## NSR Technical Notice

NSR23-TN04

Manufacture date of battery cell should be printed on NBT200 battery for NTW-1000.

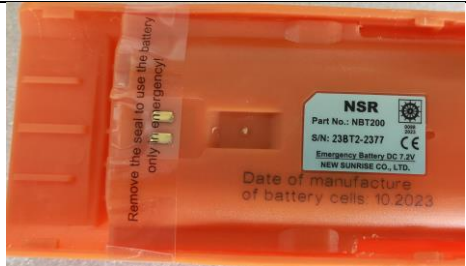
According to IMO MSC.515(105), for SURVIVAL CRAFT PORTABLE TWO-WAY VHF RADIOTELEPHONE APPARATUS installed since 1/1/2024, the original equipment manufacturer should, **in original and indelible print**, clearly mark the date of manufacture of the battery cells on the exterior.

Products of NTW-1000	Action	Example
Shipped from NSR since 14/12/2023	Manufacture date is printed with laser machine by NSR.	
Already installed on vessel before 1/1/2024	N/A	N/A
Still in stock at customers	Manufacture date needs printing with special stickers supplied by NSR.  <div style="border: 1px solid black; padding: 5px; width: fit-content; margin: 5px auto;">Date of manufacture of battery cells: 07.2023</div> Please see NSR video for the instruction.

NSR suggest the shelf life be 5 years since the date of manufacture of battery cells. The expiry date should be marked by following below requirements.

**expiry date = date of manufacture + shelf life**
